**Bid Title:** P.O. Hoffer Water Treatment Facility Glenville Lake Water Treatment Facility Post-Filter GAC Adsorption Facilities Contract No.67

**Addendum Number:** 4

**ADDENDUM NO. 4 – TECHNICAL SPECIFICATIONS AND DRAWINGS**

**Project:** P.O. Hoffer Water Treatment Facility and Glenville Lake  
Water Treatment Facility – Post-Filter GAC Adsorption  
Facilities – Contract No. 067

ATTACHMENT NO. 4	BY DCH	GLENNVILLE LAKE AND P.O. HOFFER WATER TREATMENT FACILITIES	CONTRACT NUMBER 67	SHEET 1 OF 1
ADDENDA NO. 004	DATE 01/2026	CITY OF FAYETTEVILLE, NORTH CAROLINA	HAZEN JOB NUMBER 30402-067	REFER TO CONTRACT DRAWING NUMBER C131

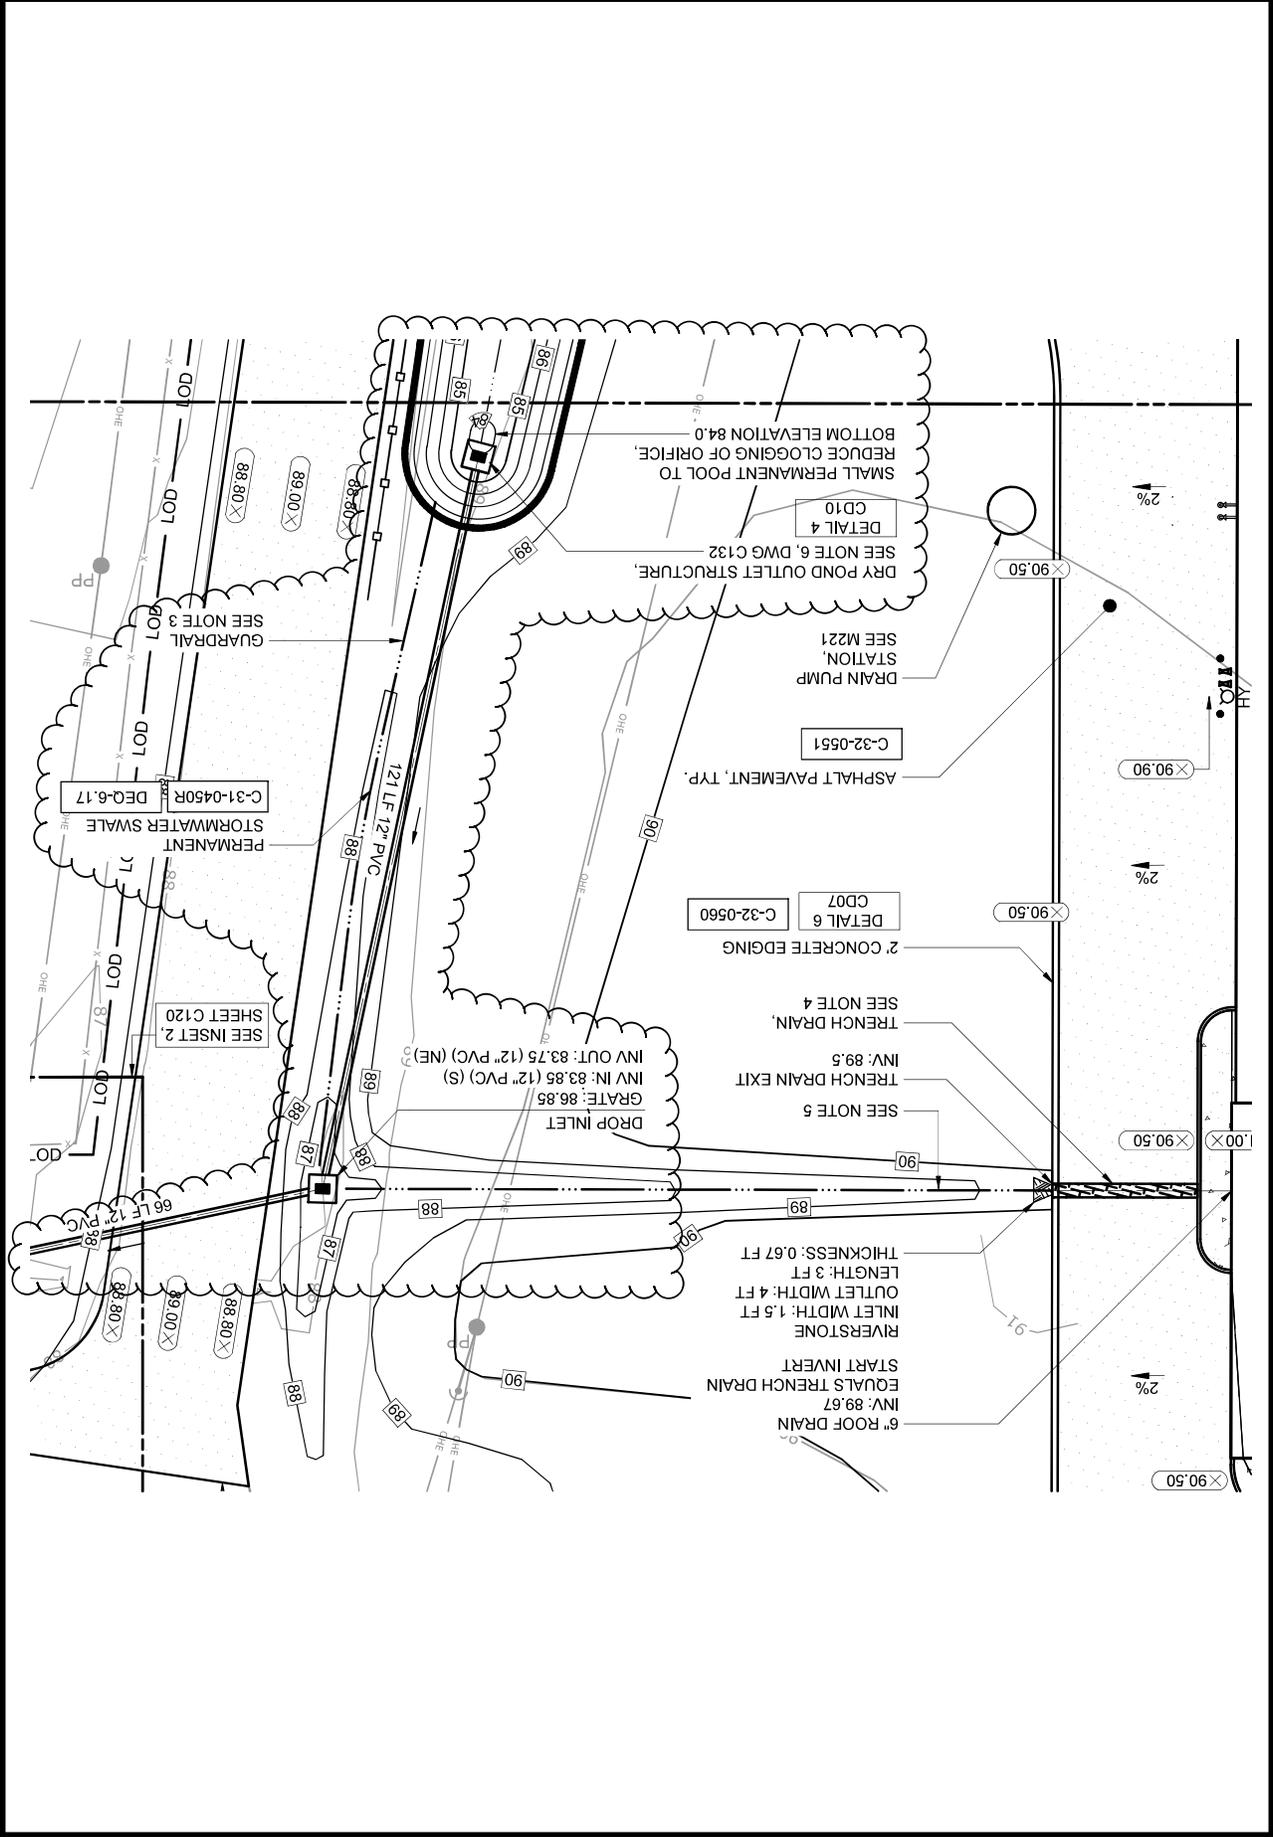
- C131 Add Riverstone Apron to Trench Drain. Add Dry Pond Outlet Structure, 12" PVC Storm Drains, Drop Inlet, Guardrail and associated grading changes as shown in **Attachment #4.**

ATTACHMENT NO. 5	BY DCH	GLENVILLE LAKE AND P.O. HOFFER WATER TREATMENT FACILITIES	SHEET 1 OF 1
ADDENDA NO. 004	DATE 01/2026	CITY OF FAYETTEVILLE, NORTH CAROLINA	CONTRACT NUMBER 67
		PUBLIC WORKS COMMISSION	HAZEN JOB NUMBER 30402-067
			REFER TO CONTRACT DRAWING NUMBER C132

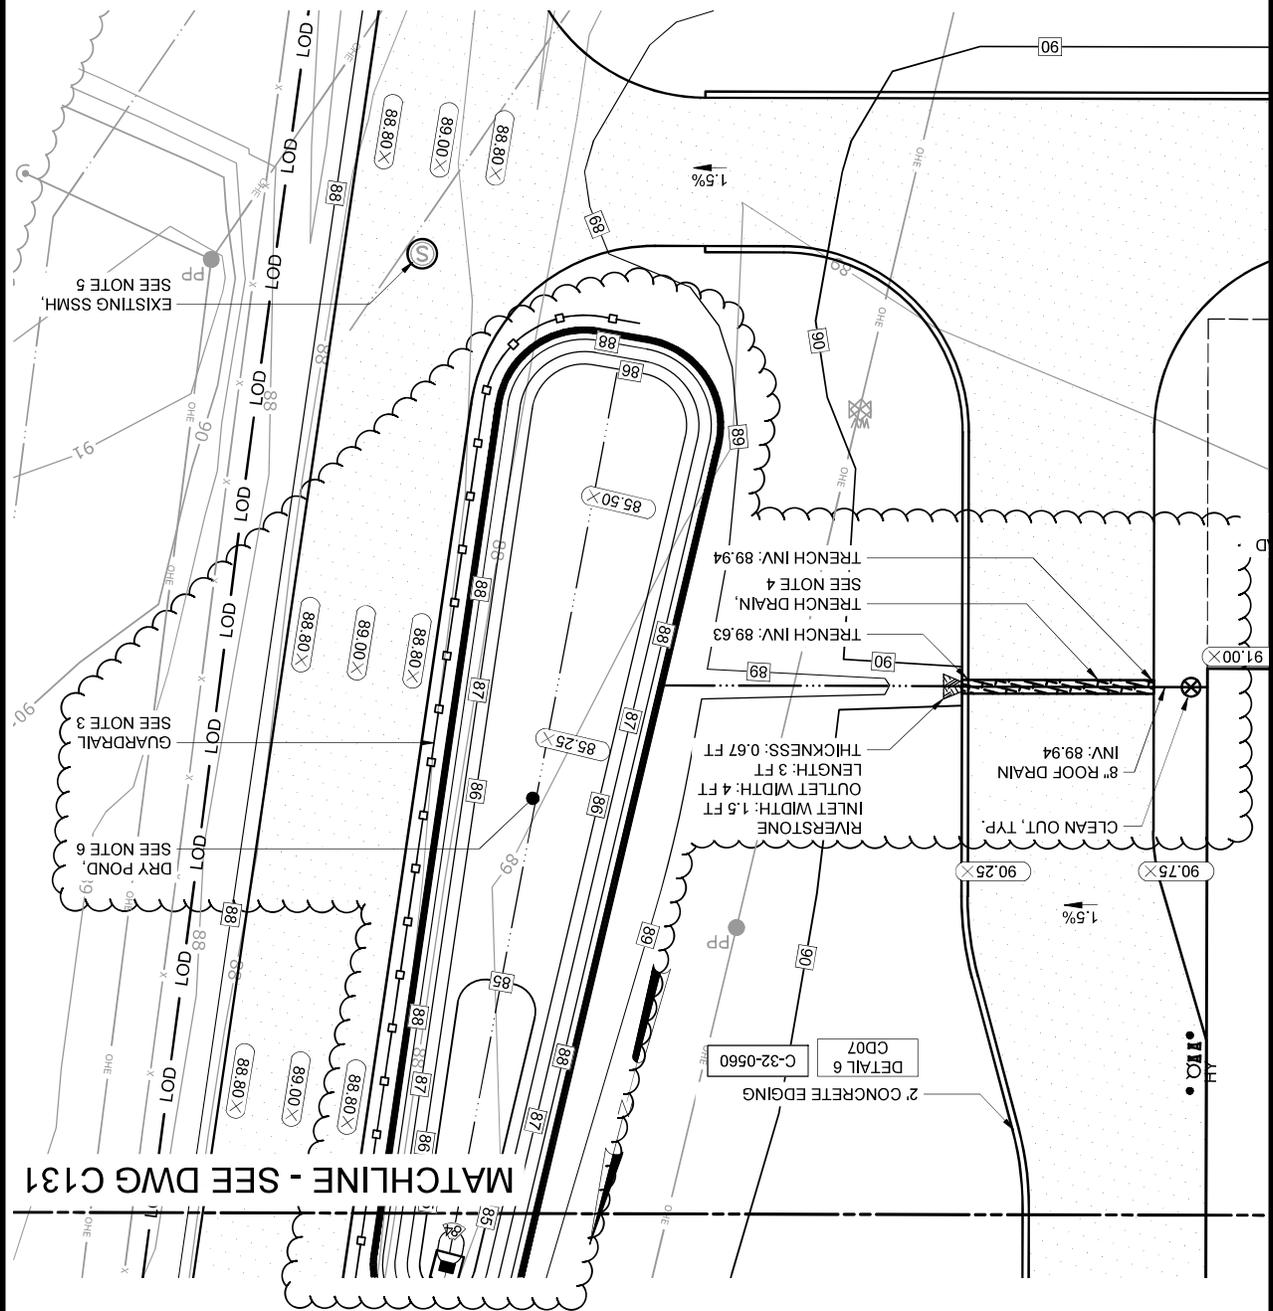
- C132 Move Trench Drain and Riverstone Apron to the opposite side of the GAC Facility. Remove Culvert and Rip Rap Outlet Pad. Add Guardrail and Dry Pond Grading and Clay Liner as shown in **Attachment #5.**

- Add Note 6: "Contractor shall install Dry Pond with Compacted Clay Liner as specified in specification 31 00 01, Section 2.08."
- CD10 Move Detail #4 – Emergency Spillway to CD11, renumber as Detail 6. Replace Detail #4 with Storm Dry Pond Outlet Structure Detail as shown in **Attachment #6.**

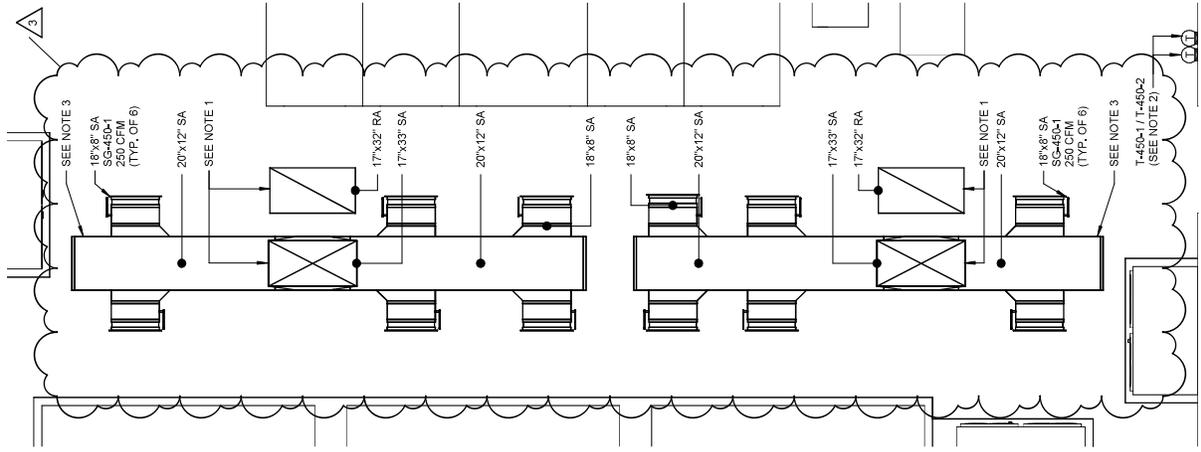
- H450 Revised AHU-450-1/AHU-450-2 unit ductwork mounting height to ensure clearance from electrical equipment. Revised plan notes, as shown in HVAC TOP PLAN, included in **Attachment #7.**

- 3
2. MANUFACTURER PROVIDED PROGRAMMABLE THERMOSTATS THAT OPERATE IN A LEAD/LAG PAIR.
  3. MOUNT DUCTWORK AT 9'-6" (BOD) ABOVE FINISHED FLOOR OR HIGHER TO ENSURE CLEARANCE FROM ELECTRICAL EQUIPMENT.

**SWBD-POH-GAC**  
SINGLE LINE DIAGRAM

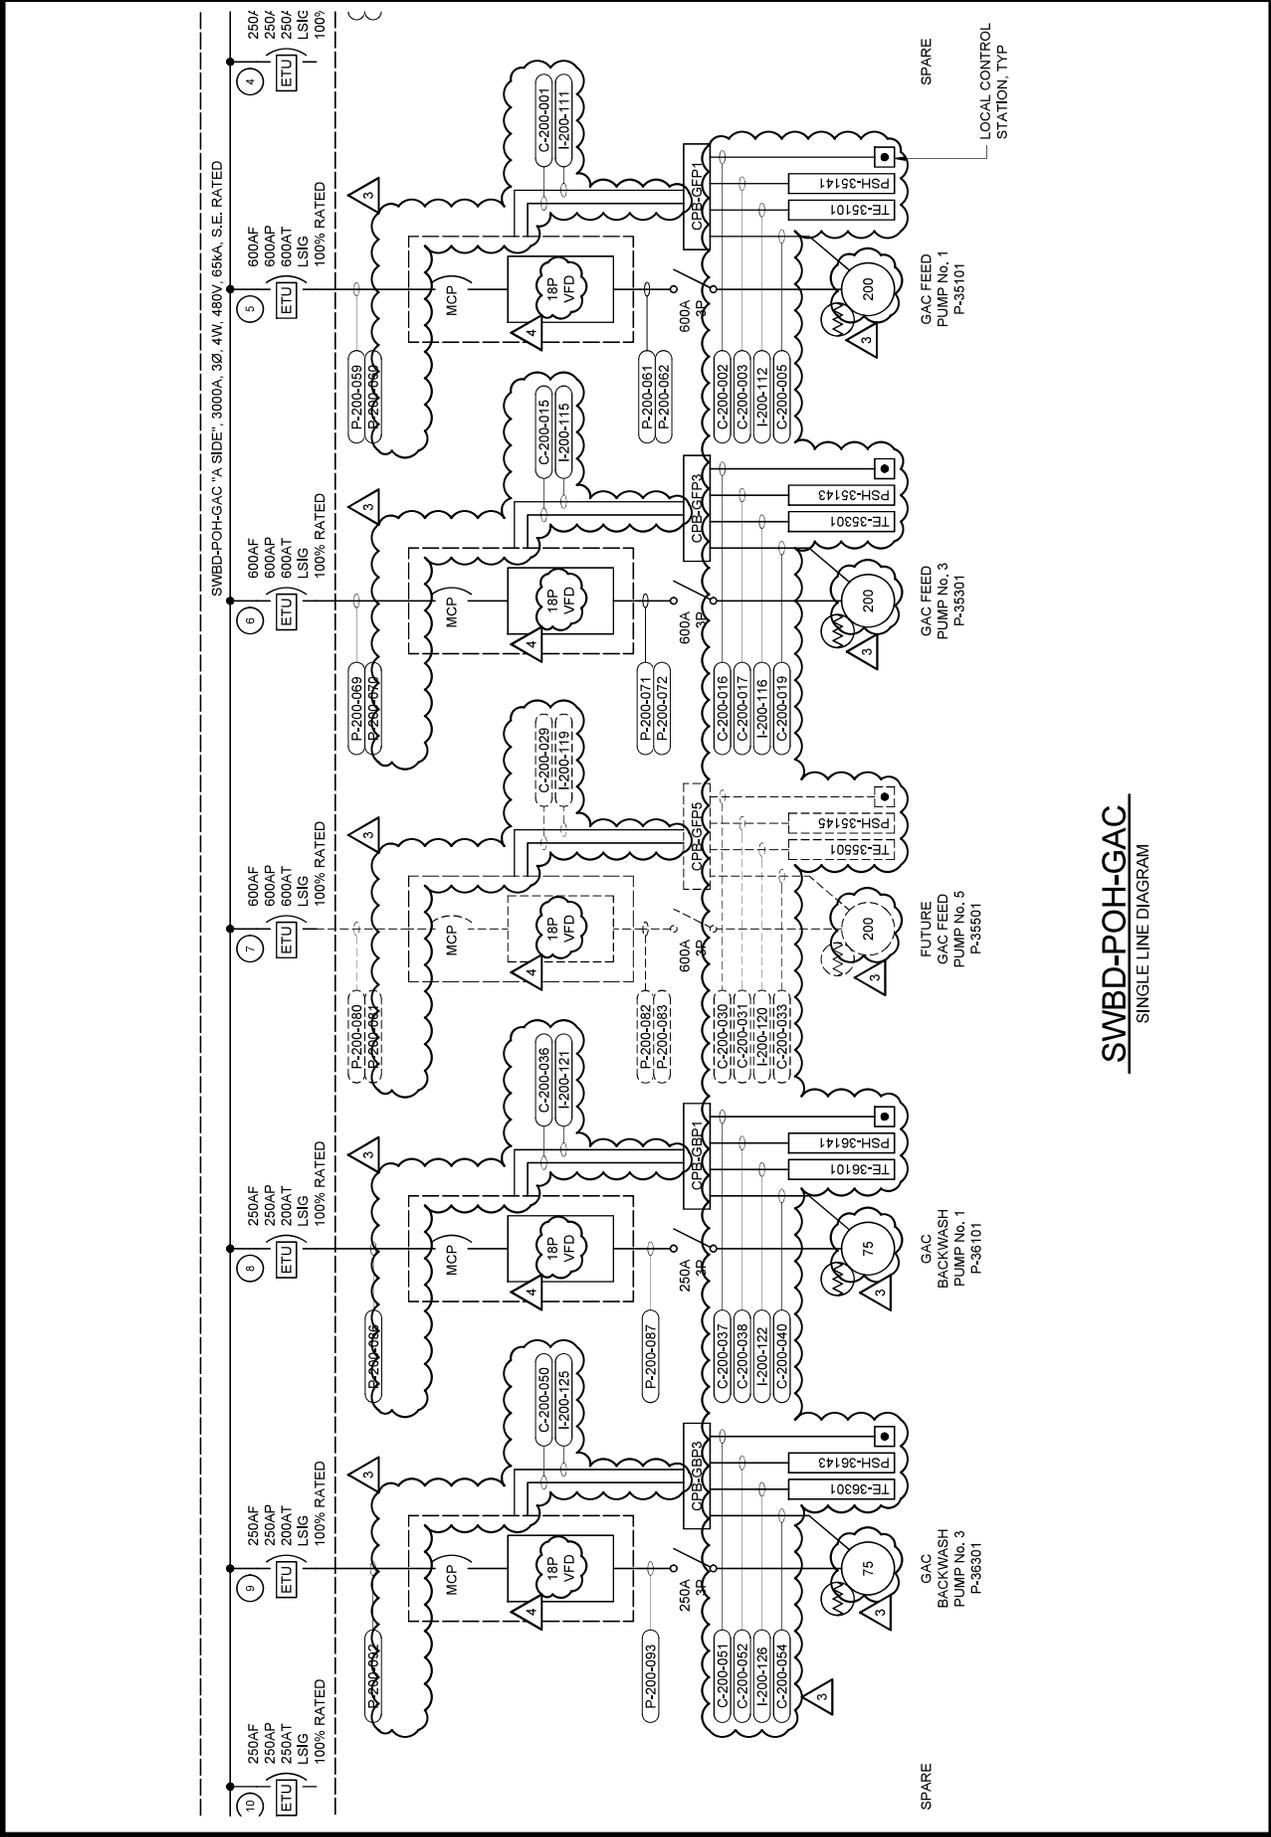
- Q25.** I have a question for the GAC Feed and GAC Backwash VFDs on this job. Normally H&S indicates what type of harmonic filtering they want for each VFD...but I don't see any type of harmonic filtering indicated on E210 & E211 drawings. Are they okay with standard 6-pulse VFDs for this job with no harmonic filtering as they have indicated below? I see harmonic distortion testing required after installation...but no requirement for harmonic analysis.

- E210 Revised single line diagram SWBD-POH-GAC to change the backwash and feed pump VFDs from 6 Pulse to 18 Pulse as shown in **Attachment #8.**
- E211 Revised single line diagram SWBD-POH-GAC to change the backwash and feed pump VFDs from 6 Pulse to 18 Pulse as shown in **Attachment #9.**

- A25.** All drives are to be 18-pulse VFDs – Drawings are being updated to reflect this. As there should be no additional harmonic mitigation needed, harmonic distortion testing after the installation is for record purposes.

**RTU-21**  
RISER DIAGRAMS

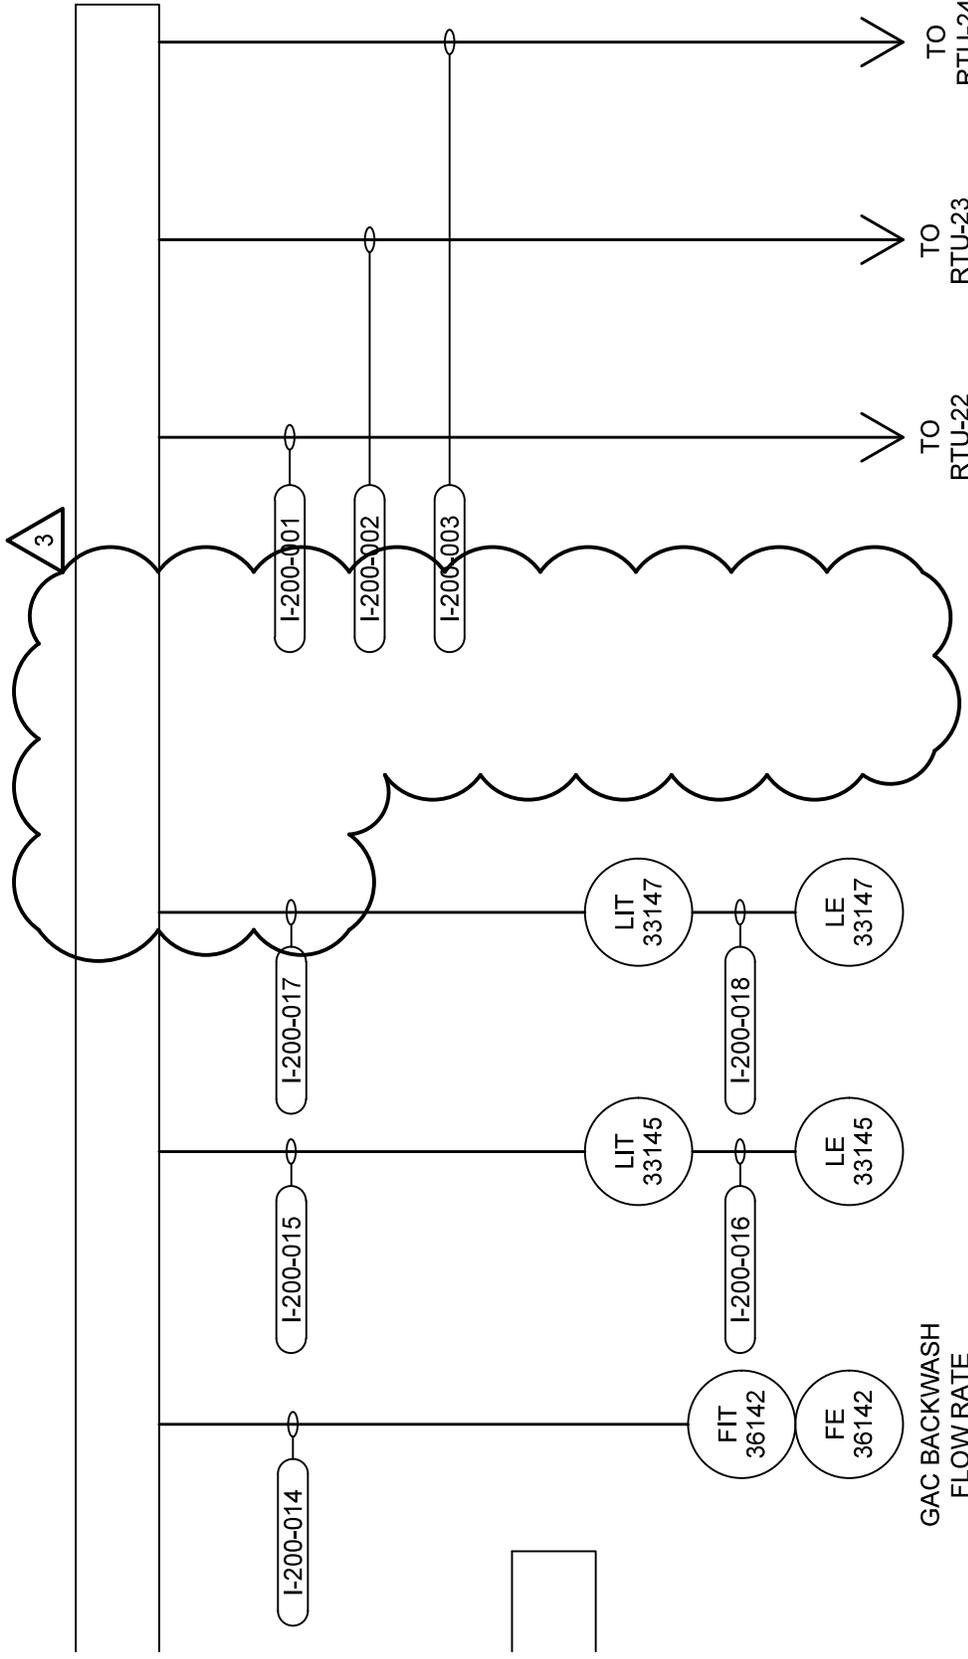
- E218 Revised Riser Diagram RTU-21 to remove FE/FIT-33146 as shown in **Attachment #10.**
- E226 Revised Conduit and Wire Schedule. Added conductors to conduit number C-200-197 for the VCP-DRAIN PUMPS 1 & 2 as shown in **Attachment #11.**

**ANALYZER**  
RISER DIAGRAMS

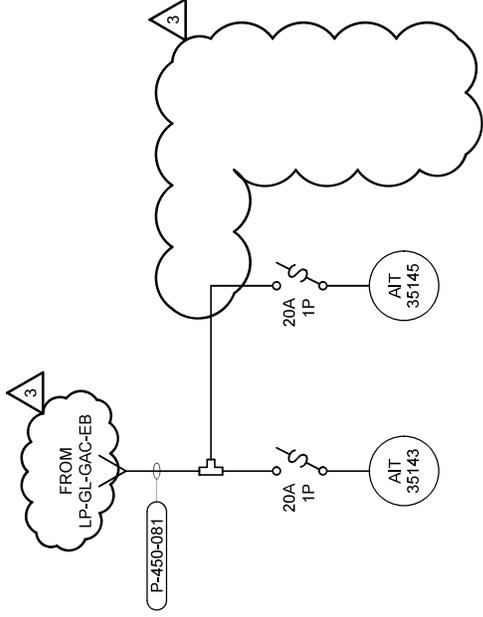
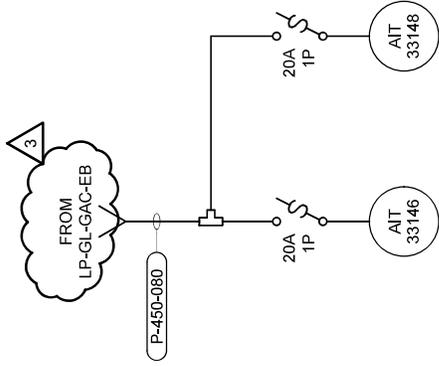
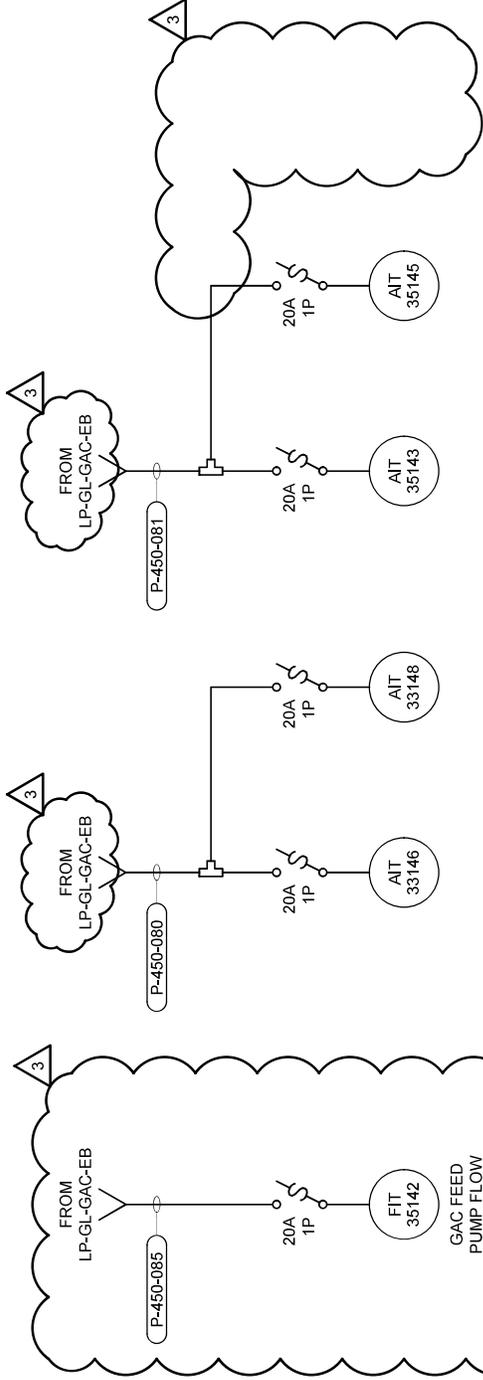
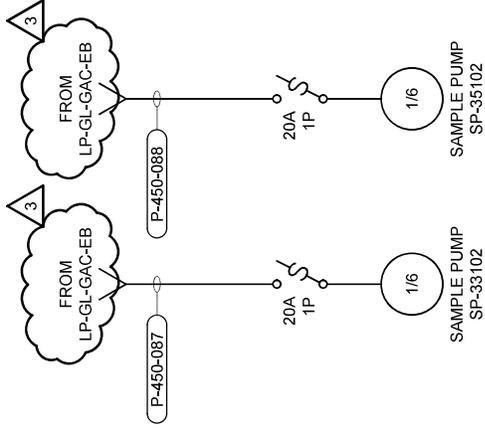
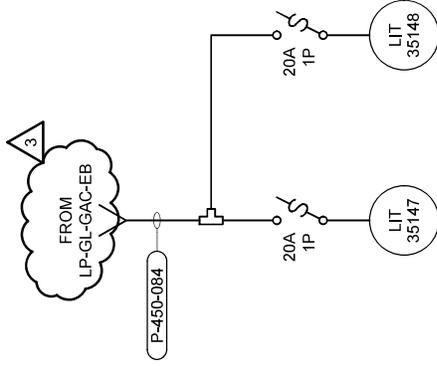
- E453 Added FIT-35142 Flow Meter riser diagram. Removed "EXISTING" from all circuit descriptions being supplied from LP-GL-GAC-EB. Removed transmitter AIT-35146 from the Analyzer riser diagram as shown in **Attachment #15.**
